# Review of GeoScience's Groundwater Extraction Simulations for the Proposed CalAm Monterey Peninsula Water Supply Project

Preston Jordan, Christine Doughty,  
and Curt Oldenburg

1 September 2016

# Perched Dune Sand Aquifer Conceptual Model

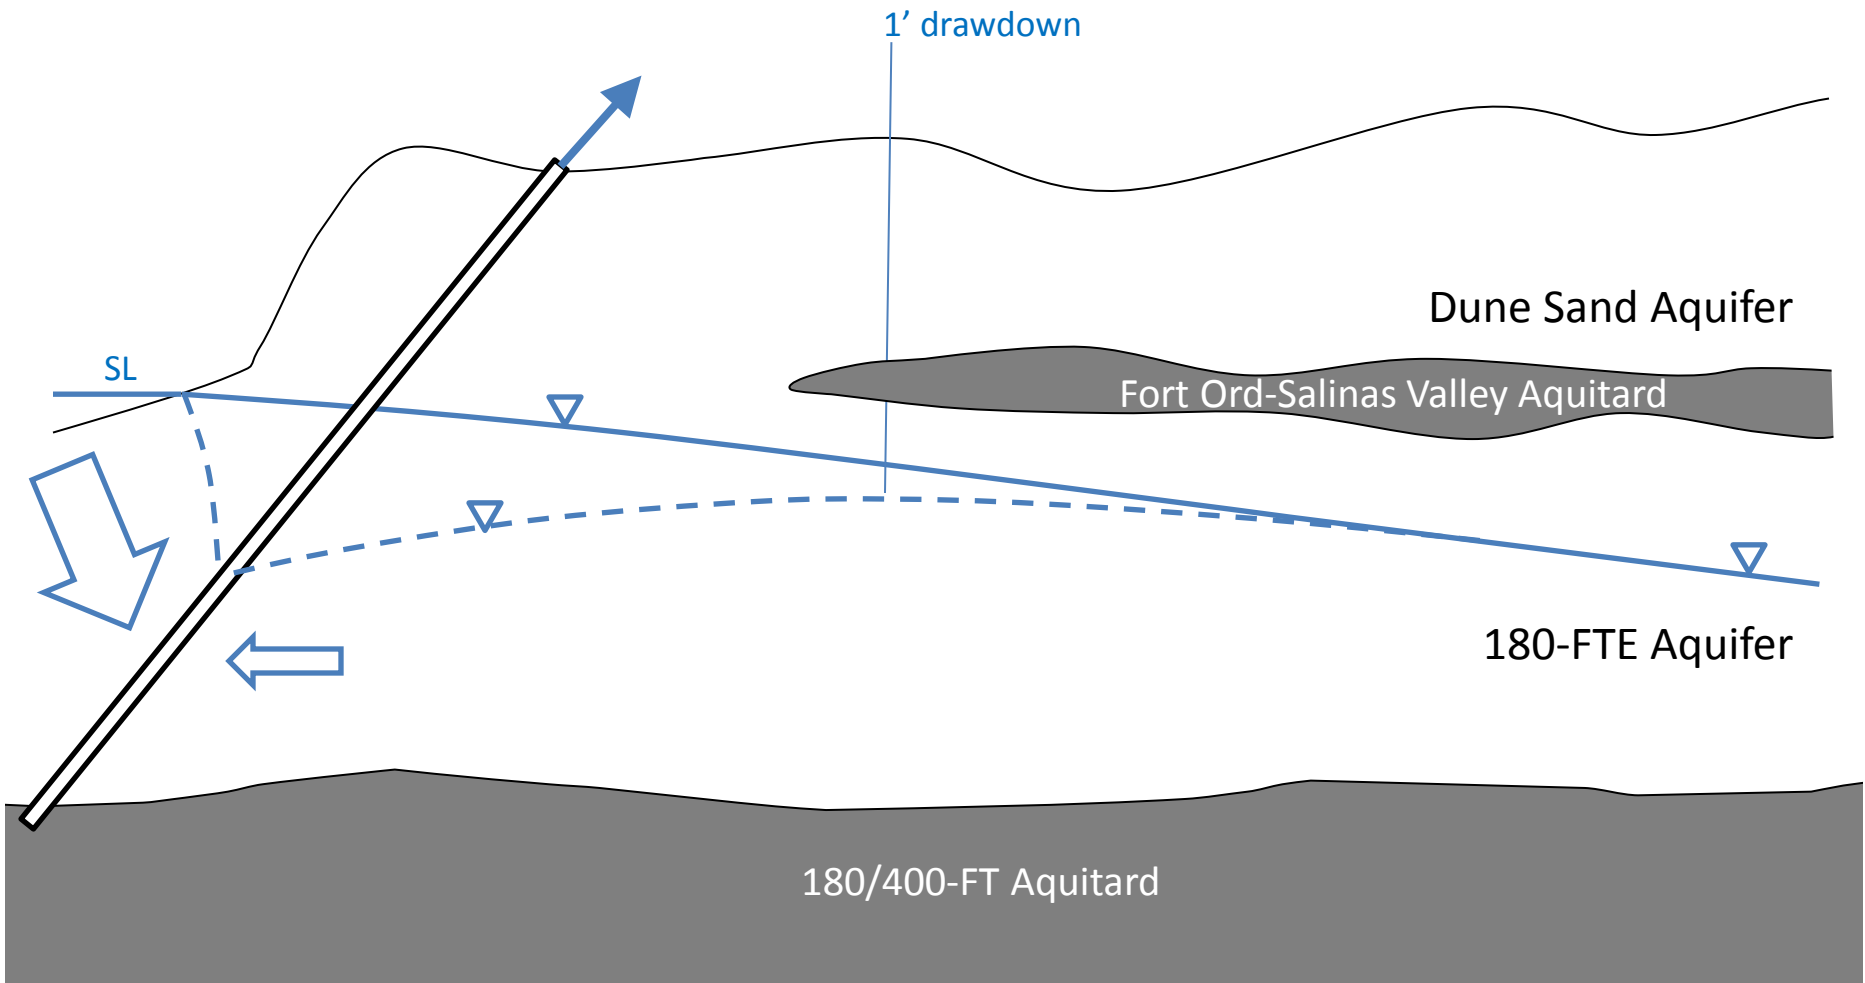
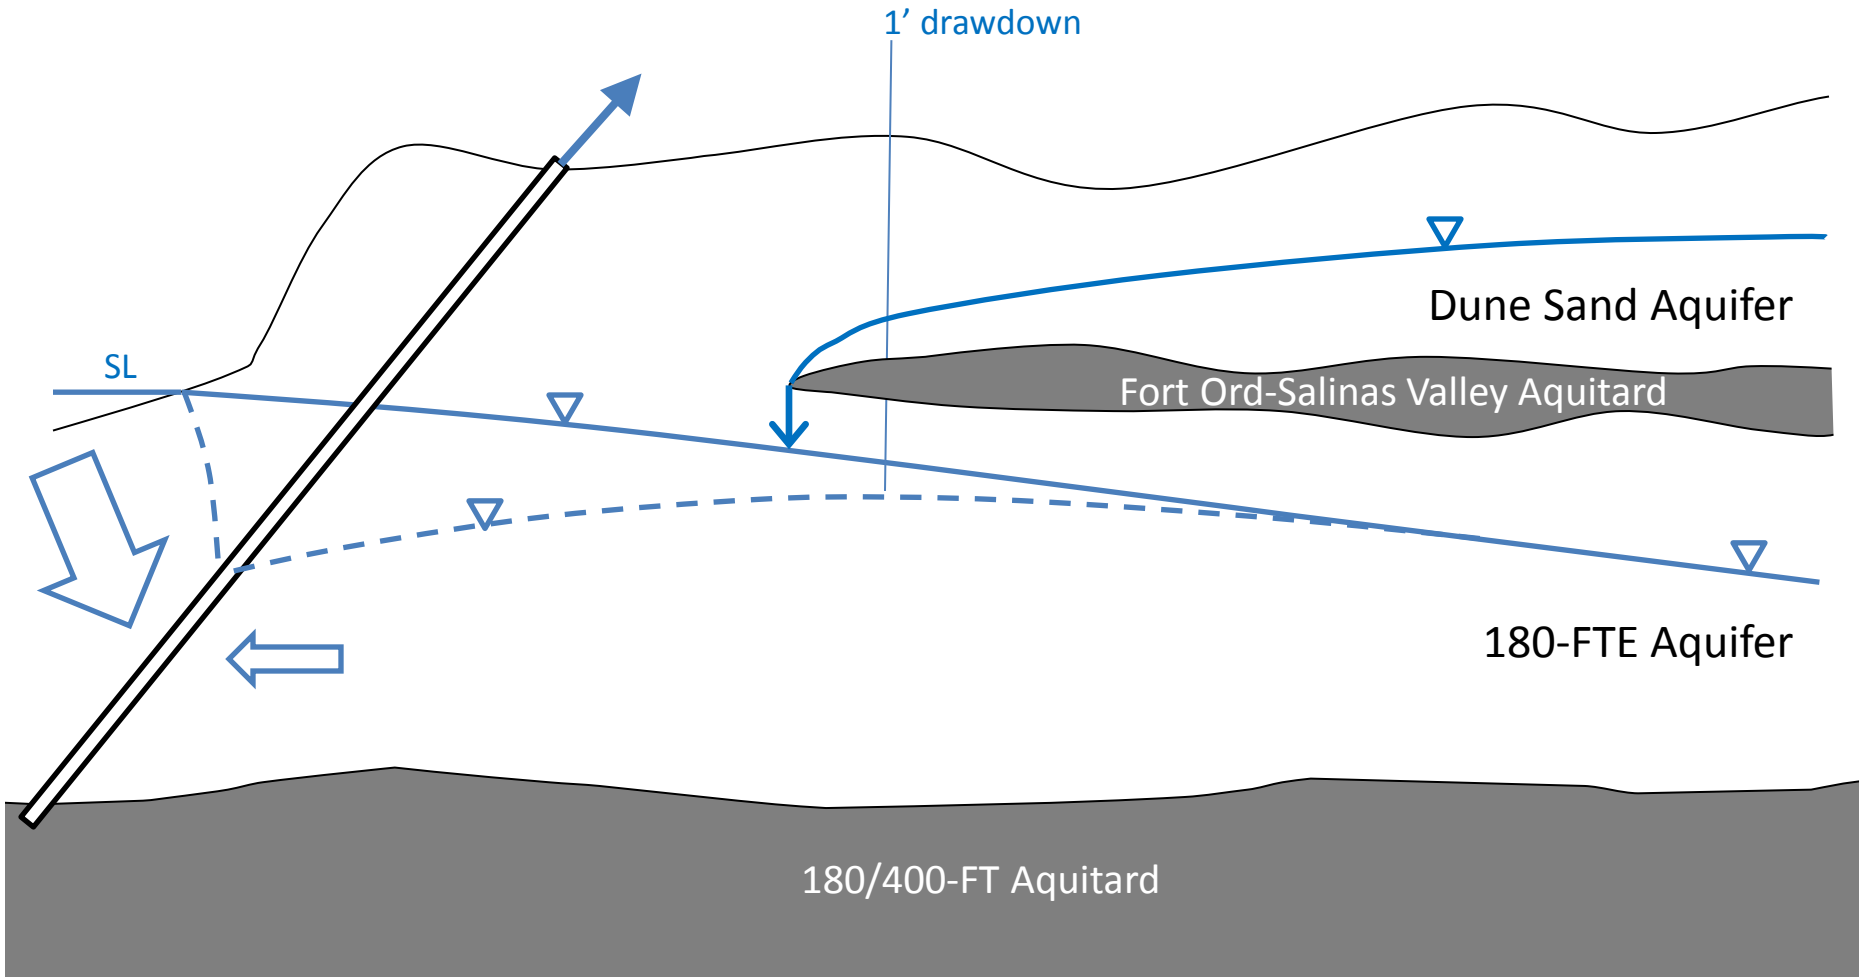
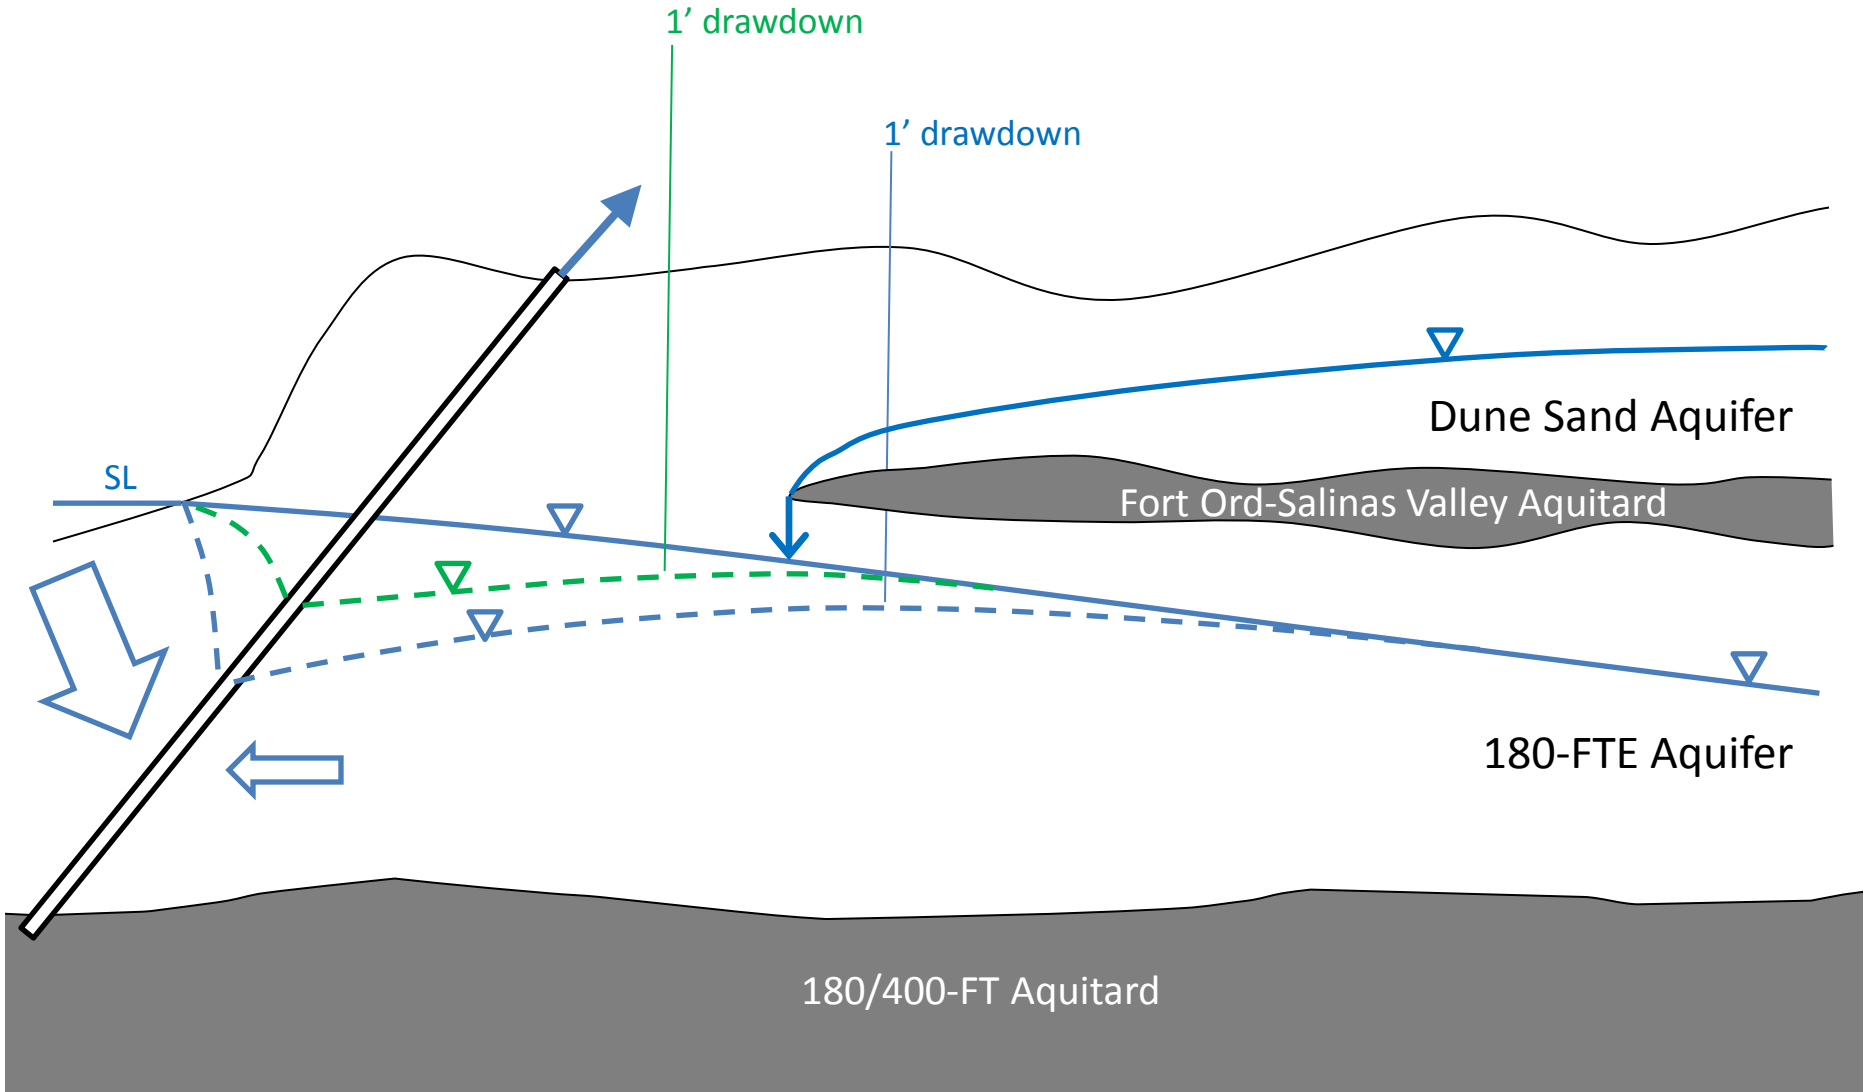
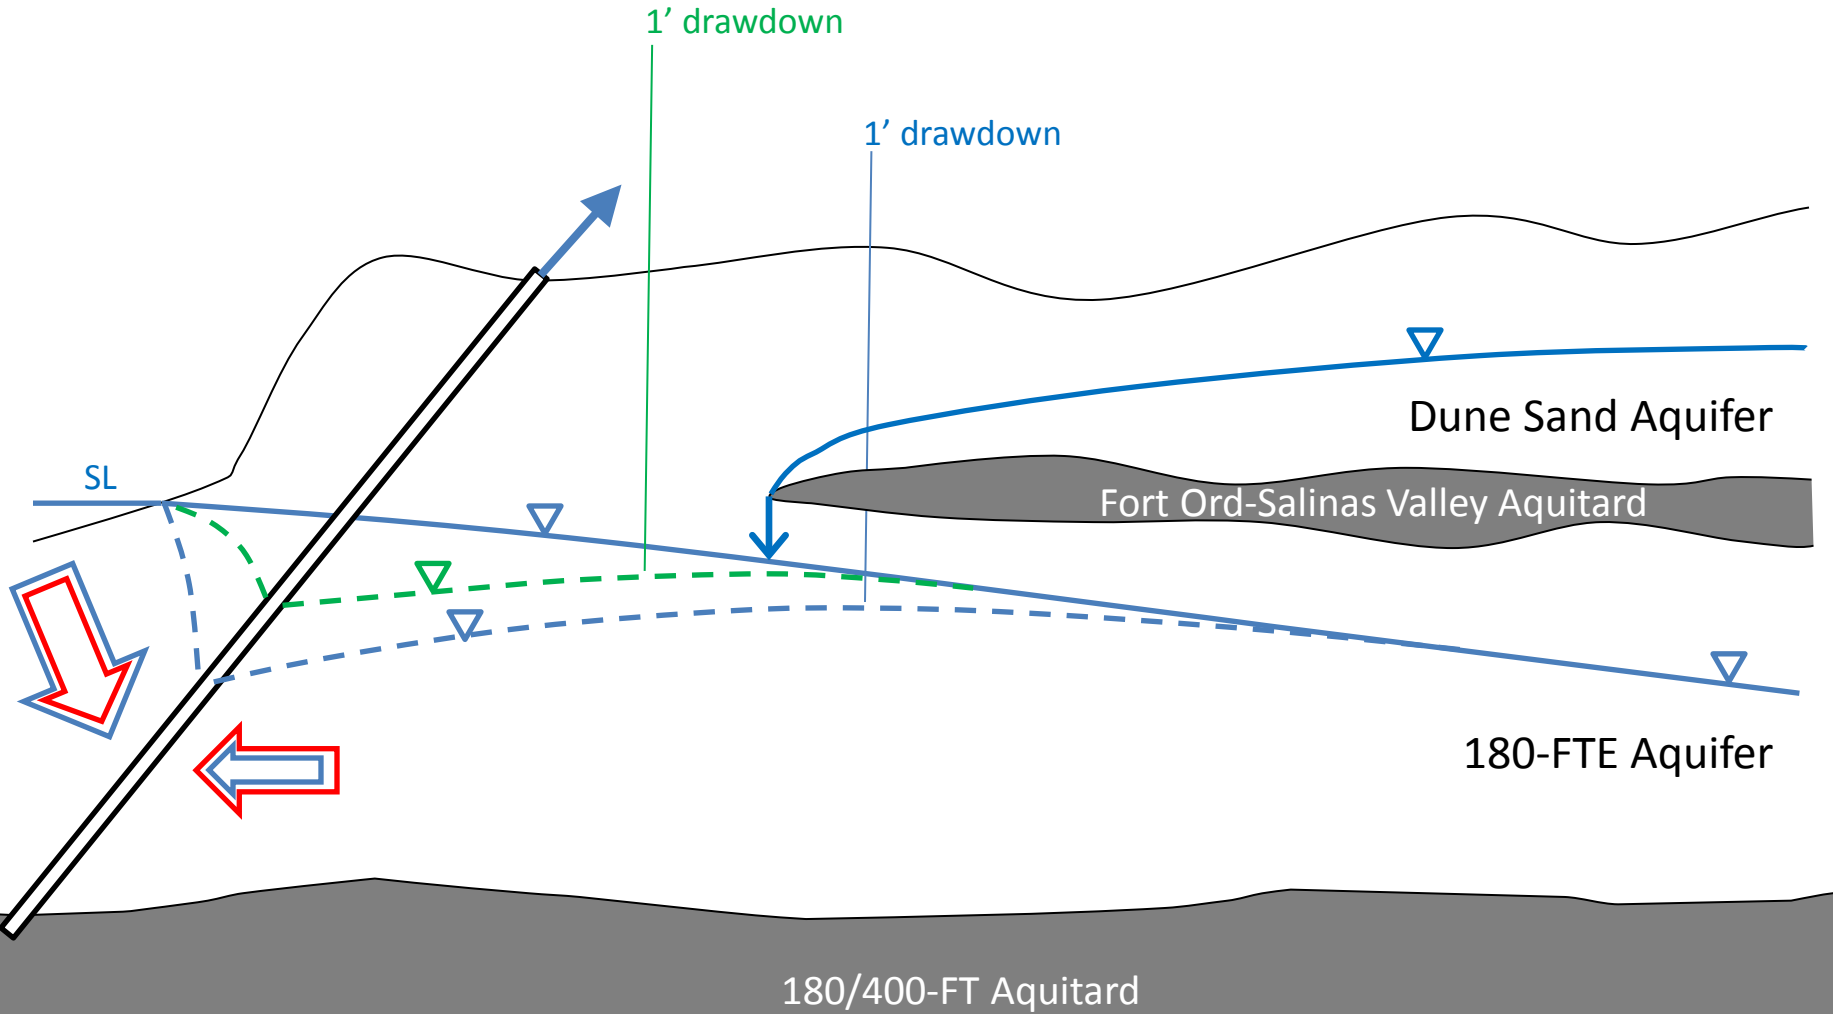
- Groundwater simulation outputs verified using same inputs and same models
- Hydrostratigraphic model deficient due to absence of Fort Ord-Salinas Valley Aquitard
- Aquifer hydraulic conductivities input to simulations are too large
